Agenda
Hearing Examiner Meeting
Monday, July 12, 2021
Join the Zoom meeting [here](#)
Public Telephone Access: (206) 337-9723 or (253) 215-8782
Meeting ID No. 872 2126 7401

S2021-104 - Preliminary Plat of South Orchard

**CITY OF RICHLAND DEVELOPMENT SERVICES DIVISION
STAFF REPORT TO THE HEARING EXAMINER**

PROPOSAL NAME: South Orchard - Preliminary Plat

C001
1 of 18 Sheets

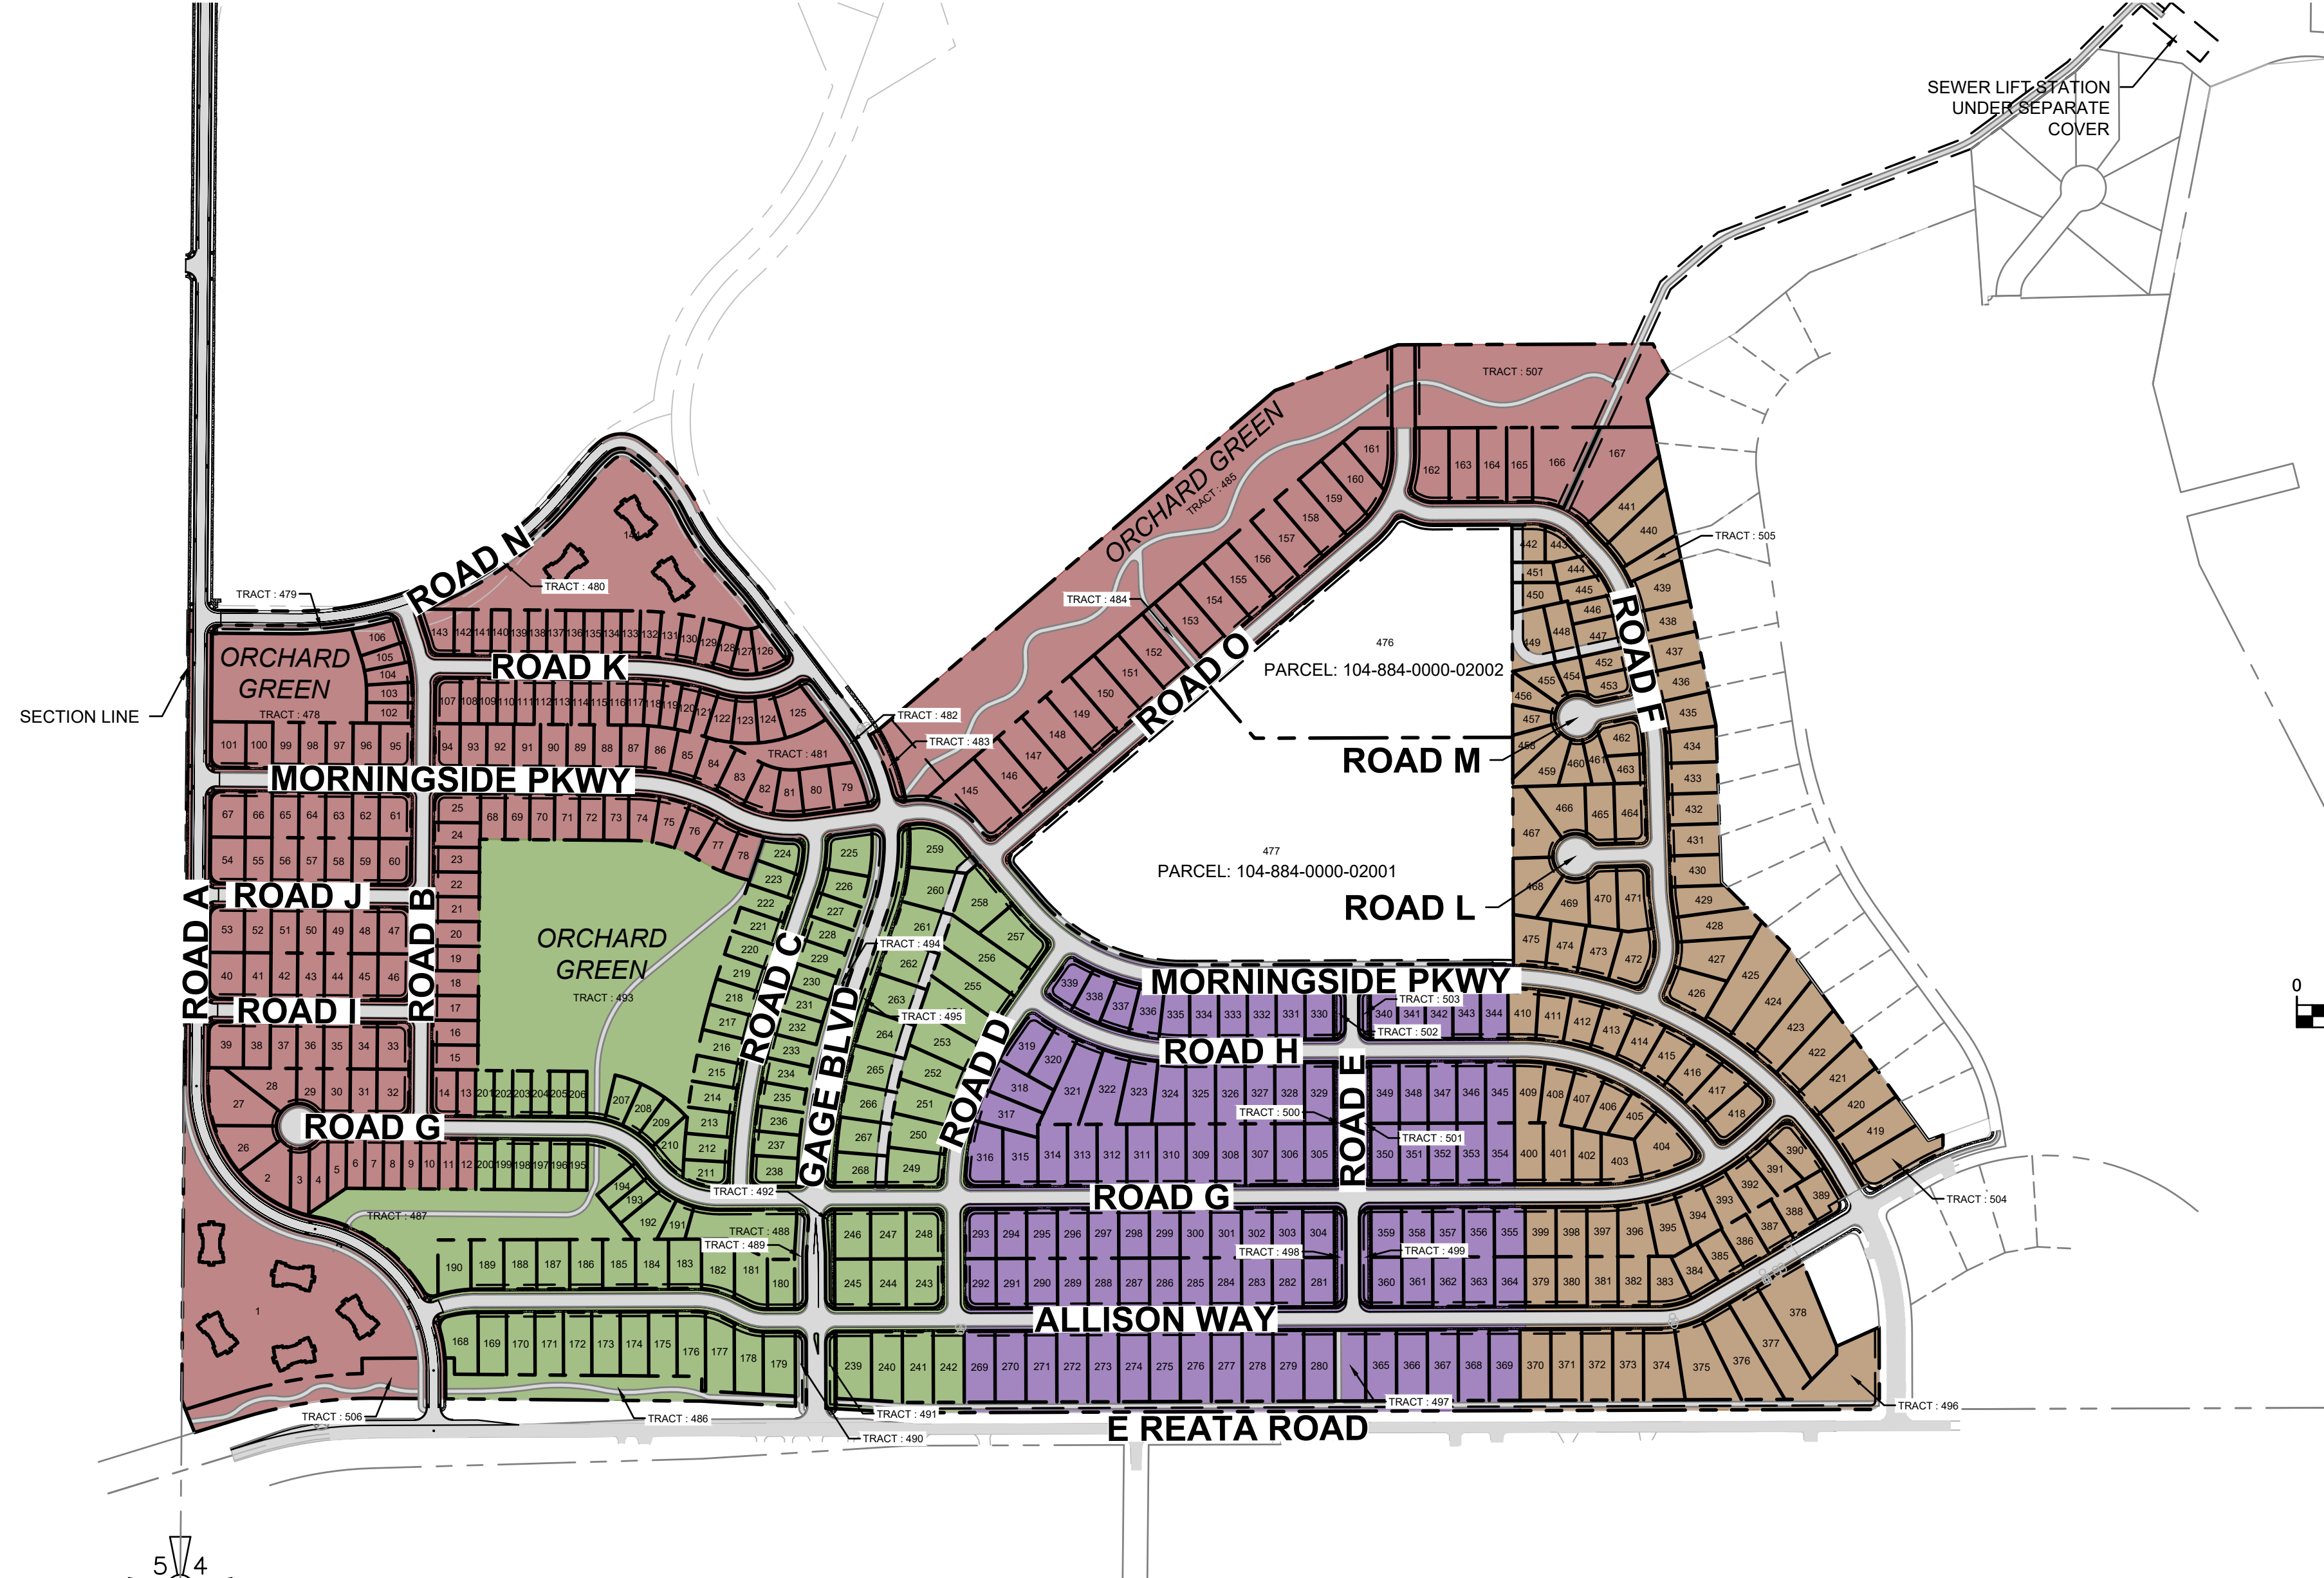
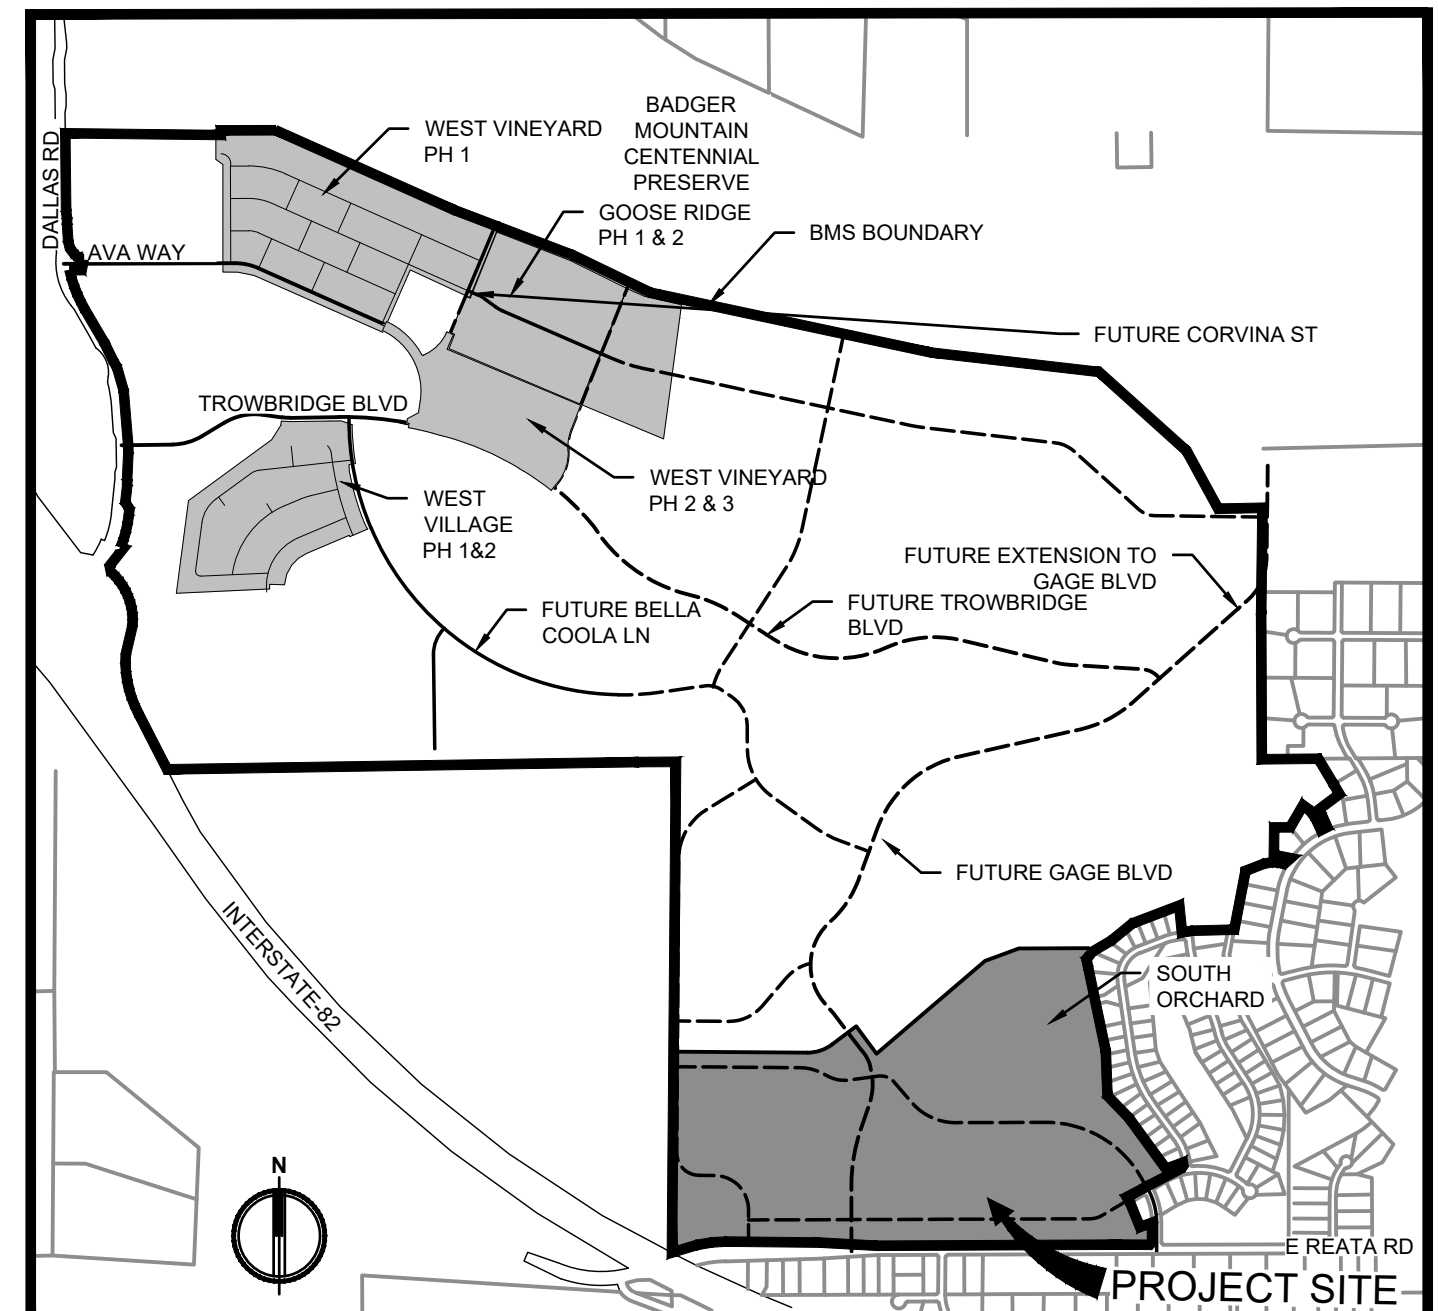
With respect to lot dimensions, there are some concerns about the lots fronting the cul-de-sac bulbs of Roads “M” and “L”; as pie-shaped lots have proven problematic in meeting maximum front setback limitations. On Sheet C001 (Exhibit 2) note #3 states the need for setback deviations for some lots. Staff does not agree with this approach. Instead, the plat should be designed around the building setback requirements of the underlying BMS zone. Proposed approval condition #83 addresses this concern by restricting the approach described in note #3; thereby notifying the developer that all lots proposed on final plats shall be designed to reasonably accommodate home construction within the setback limits imposed by the LUDR.

3. Any future storm drainage tracts will be dedicated to the city for ownership. The "Tract Note" on sheet C001 of the pre-plat should be amended to include this.

83. Note #3, as shown on sheet C001 of Exhibit 2, is not valid and may not appear on any subsequent final plat(s). All lots shall be designed to meet setback requirements of the applicable BMS zoning district(s).

1 MAJOR COLLECTOR SECTION WITH MEDIAN OR TURN & EDGE TYPE B & D

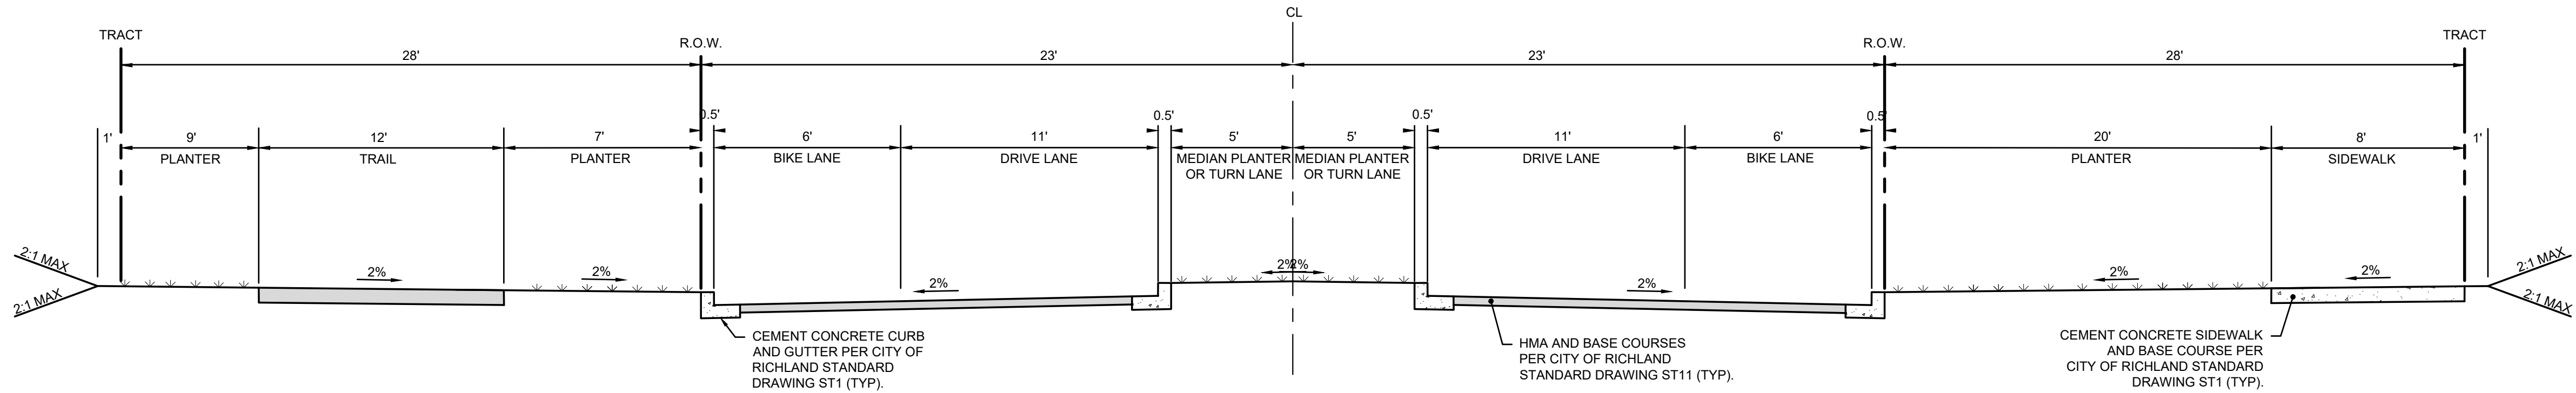
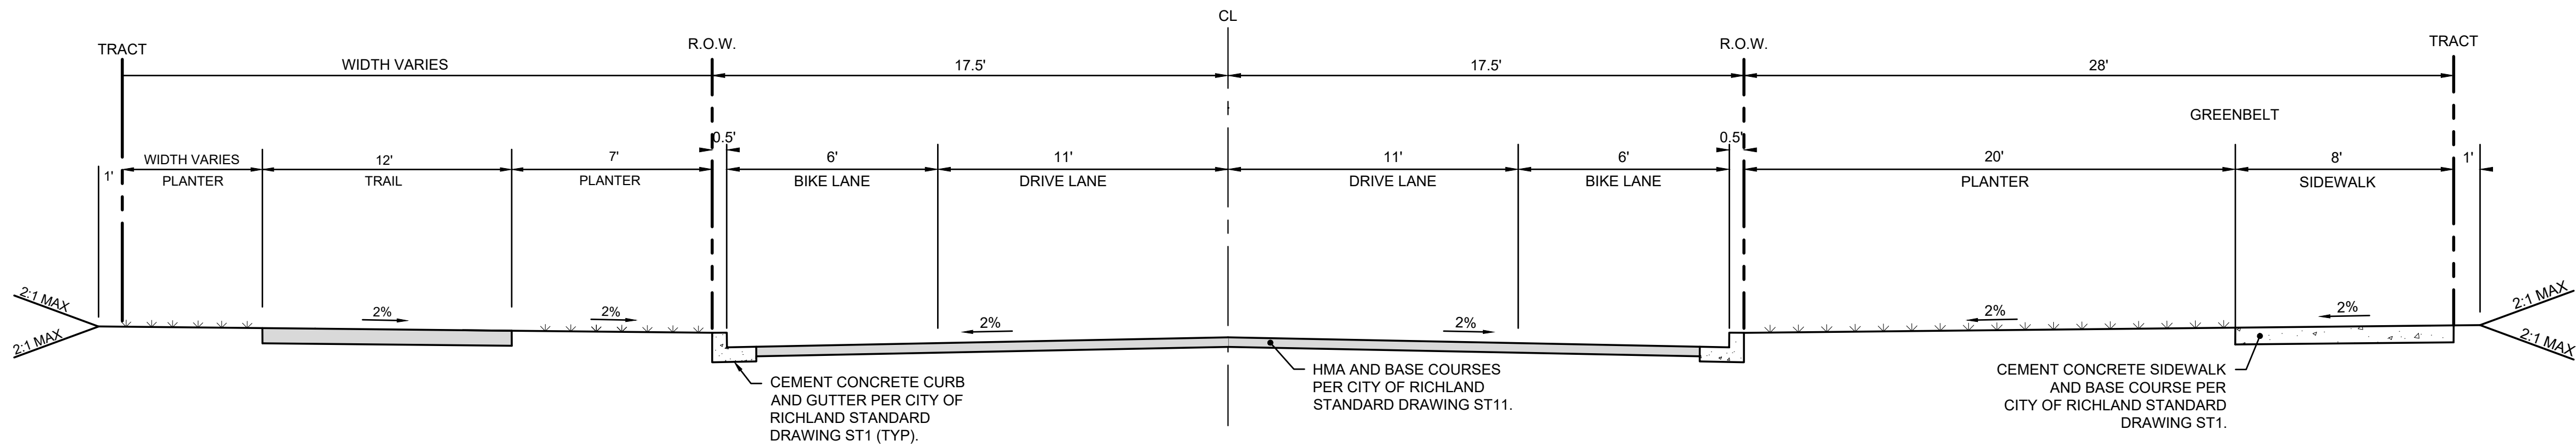
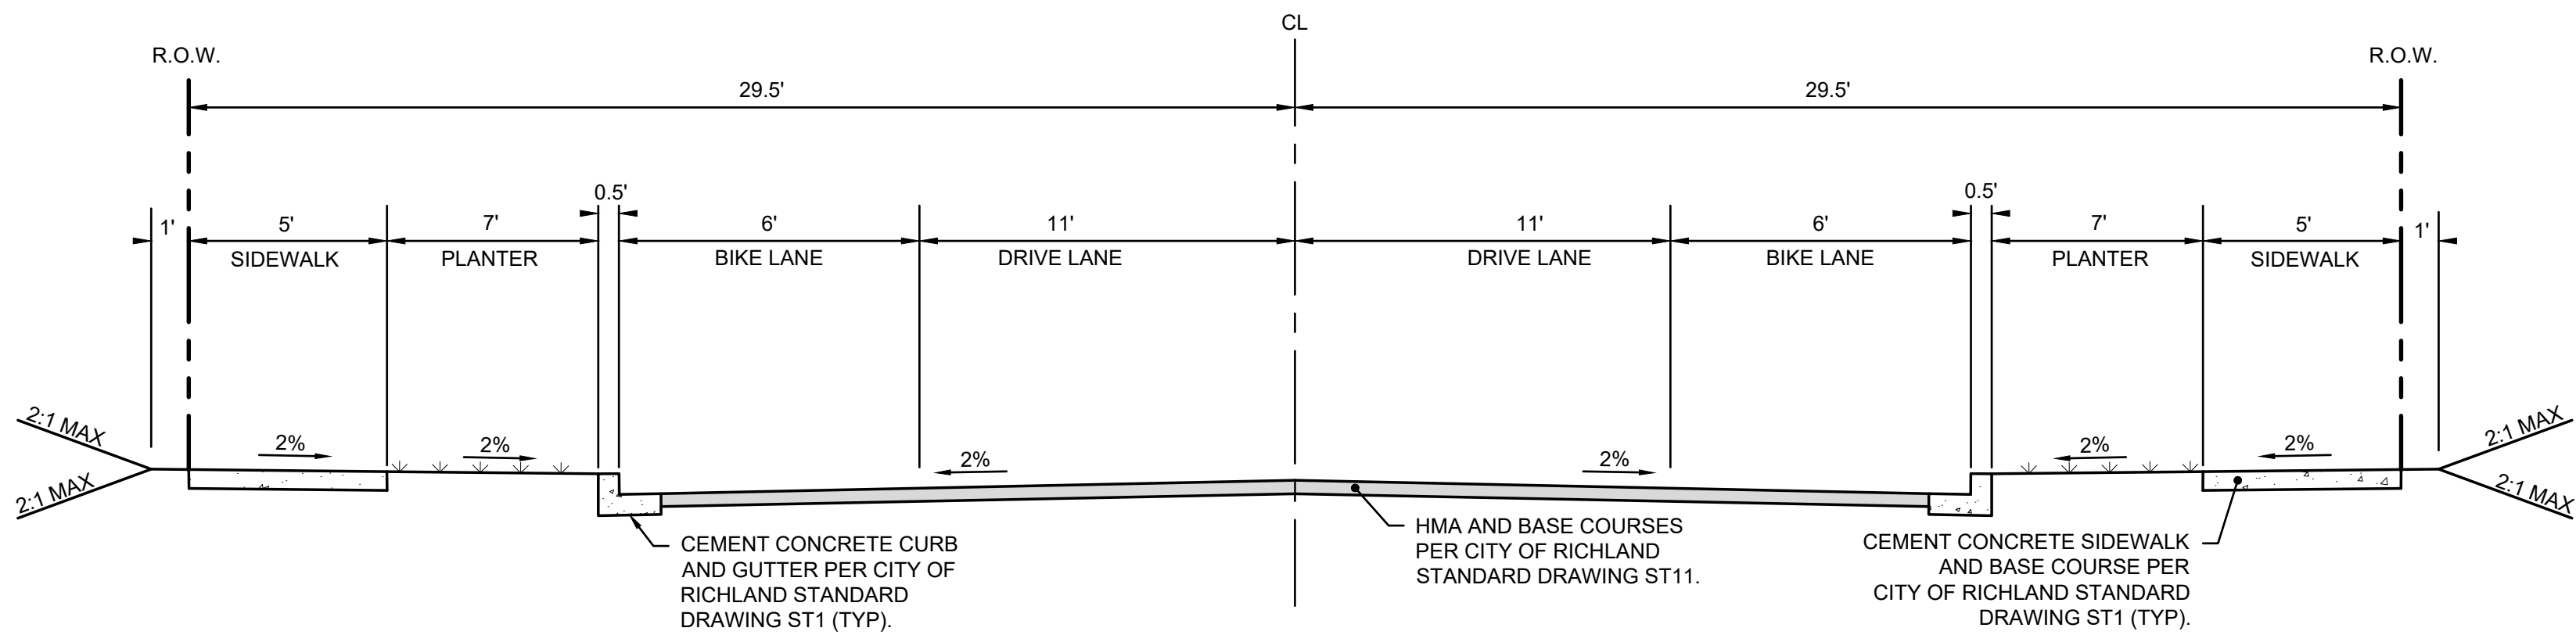
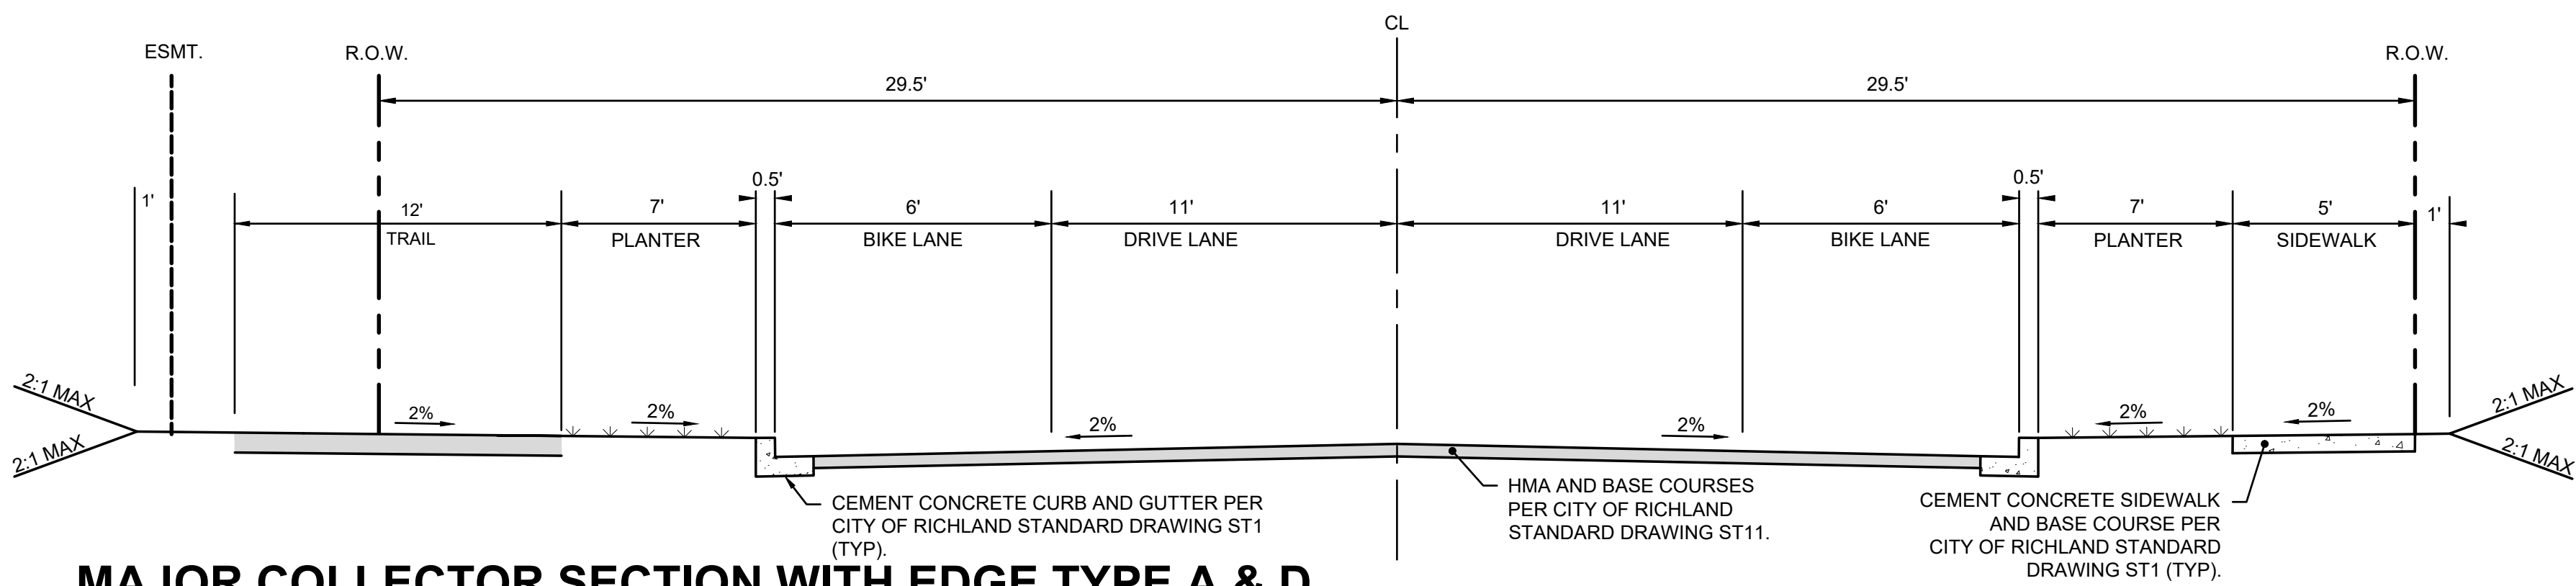
23. Sheet C002 identifies a road section with a median, however it is not clearly identified where that road section is intended to be within the pre-plat. Medians shall not interfere with left-turning movements at intersections. The developer shall obtain approval from the City's Traffic Engineer for all median designs.
